Agenda
Village of Arlington Heights
Design Commission
Community Room, 3rd Floor

Item: DC#14-037 - 923 N. Kaspar Ave. - SF/Teardown

STAFF DESIGN COMMISSION REPORT

Project Name: 923 N. Kaspar Ave.
Project Address: 923 N. Kaspar Ave.
Prepared By: Steve Hautzinger

A-2

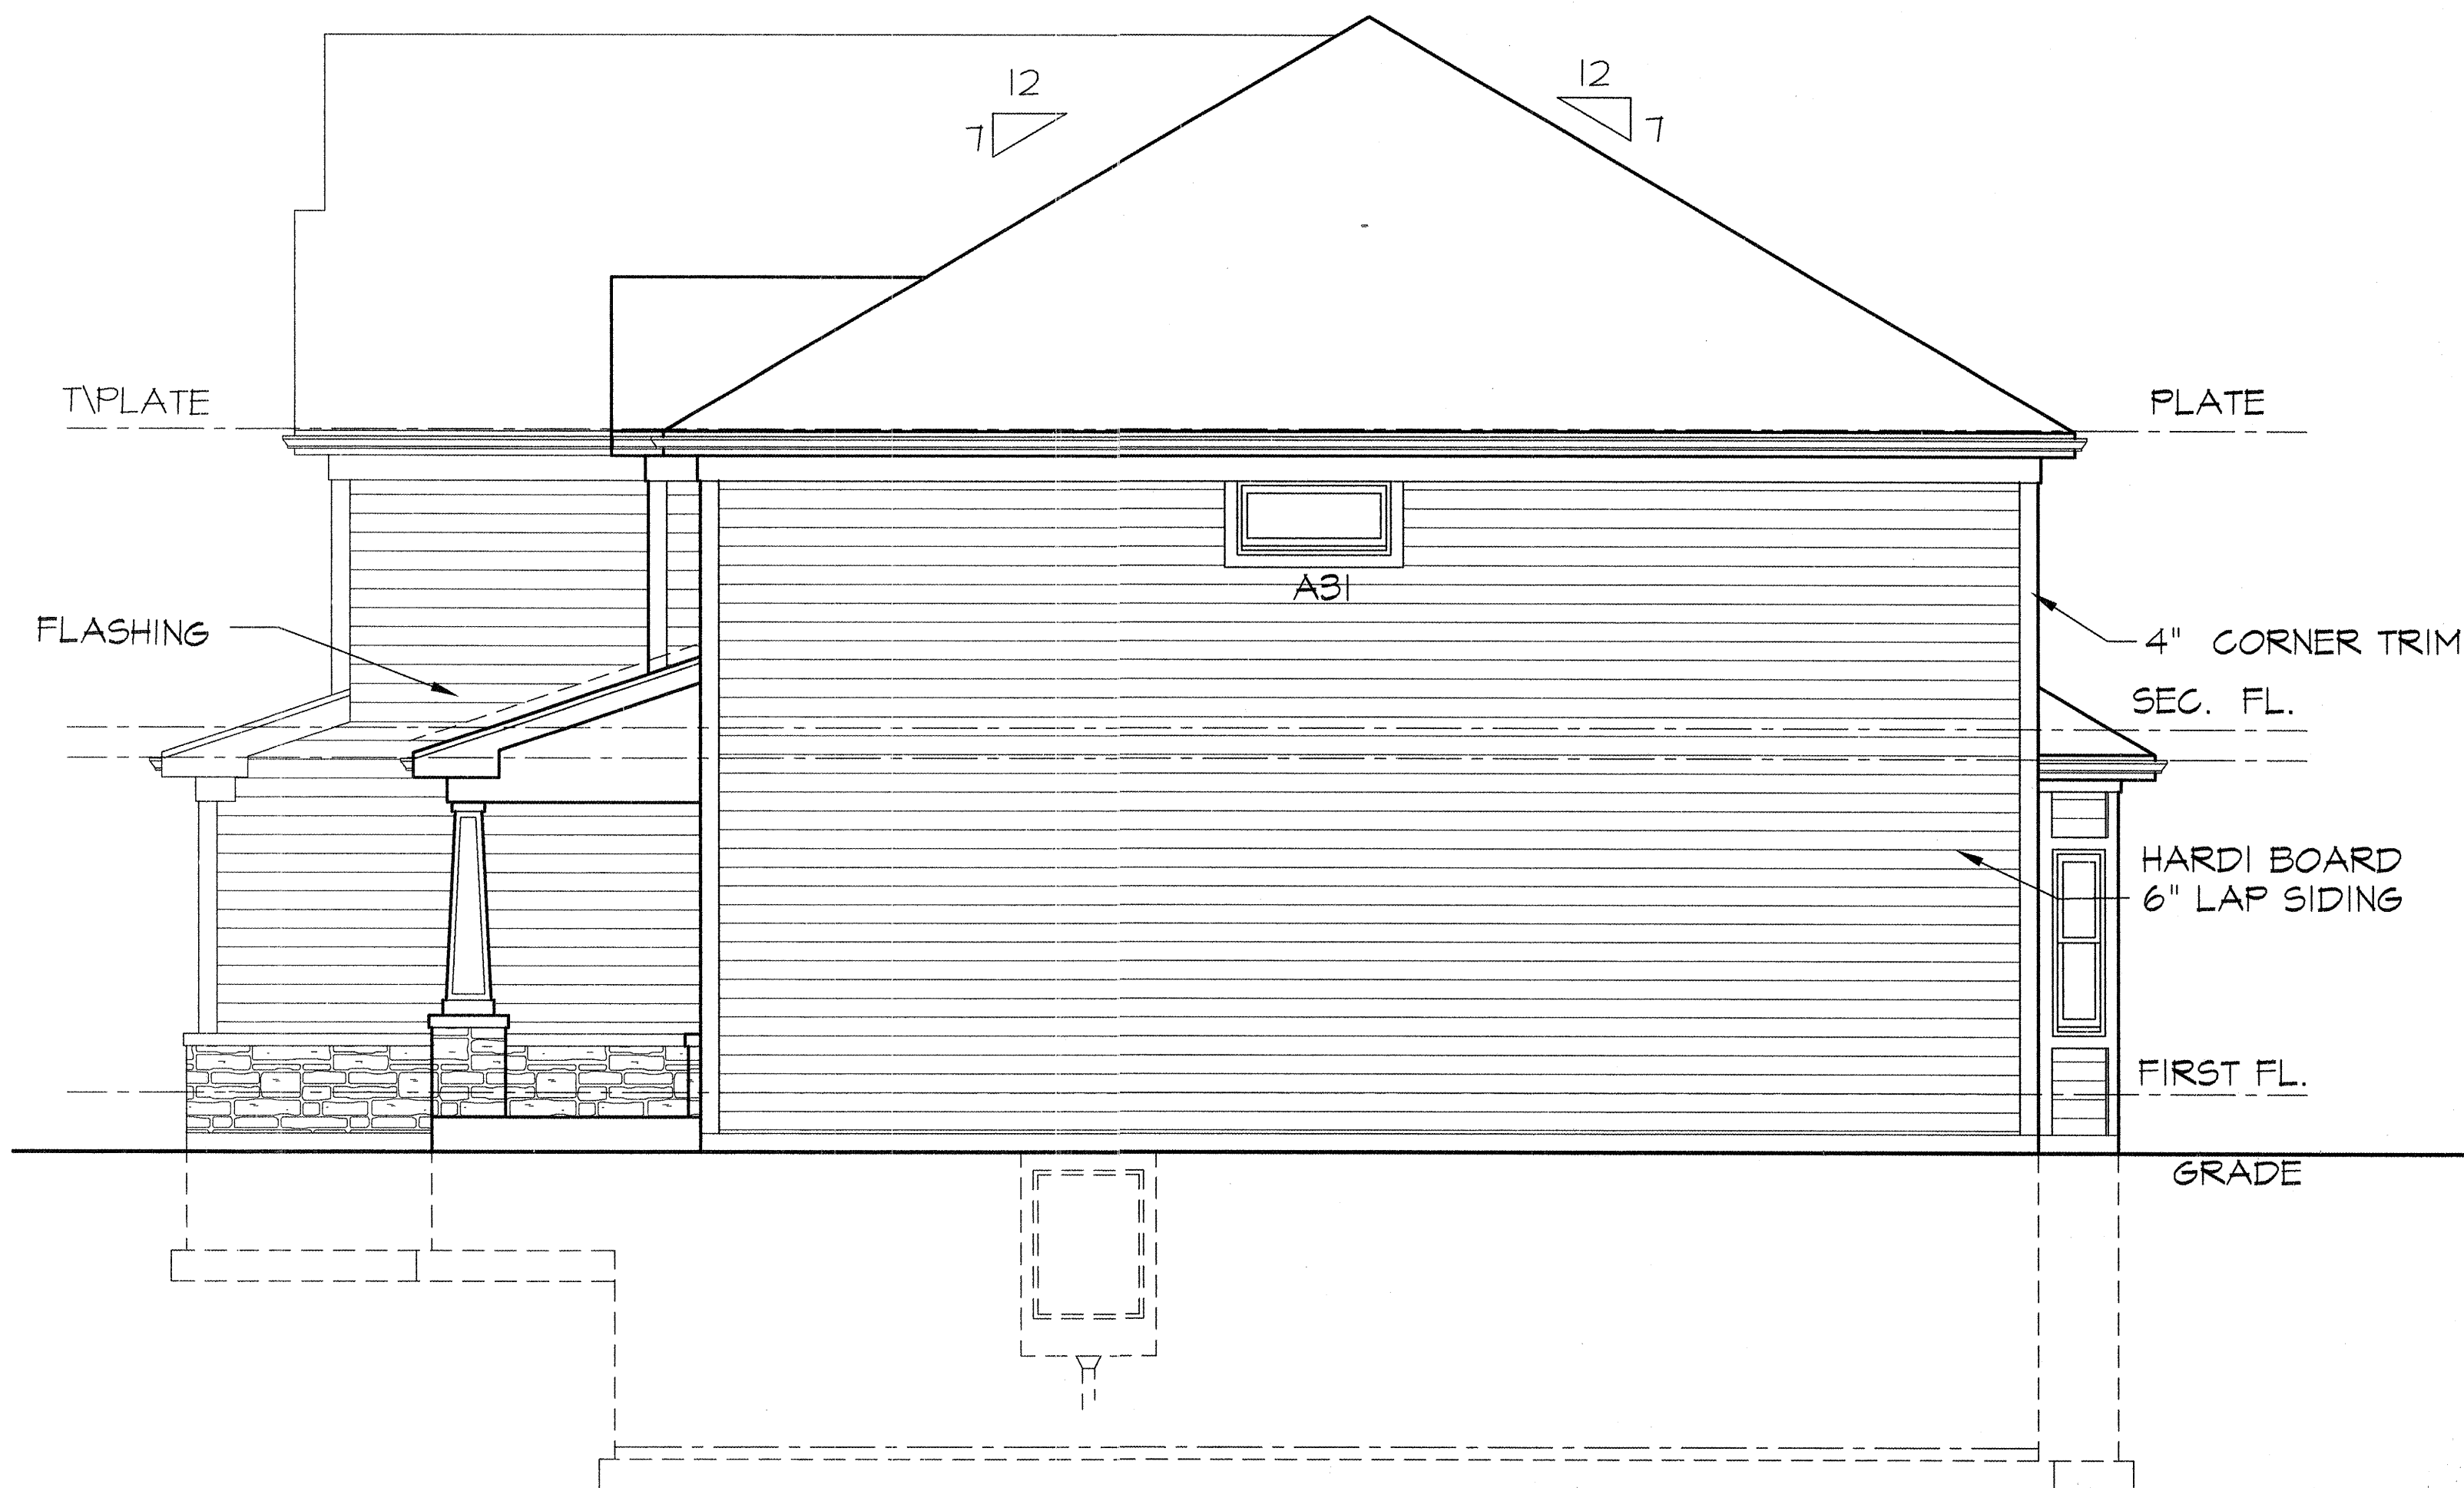
1. Recommend adding double hung windows to the right side elevation in the Living Room and Loft.
2. Recommend lowering the transom window in the stairwell on the right side elevation and changing it to a double hung window.
3. Recommend adding double hung windows to the left side elevation in the Garage and Bedroom 3.
4. Recommend adding decorative grilles (grids) to all double hung windows on the sides and rear, to match the front elevation.

1. Recommend adding double hung windows to the right side elevation in the Living Room and Loft.
2. Recommend lowering the transom window in the stairwell on the right side elevation and changing it to a double hung window.

3. Recommend adding double hung windows to the left side elevation in the Garage and Bedroom 3.
4. Recommend adding decorative grilles (grids) to all double hung windows on the sides and rear, to match the front elevation.
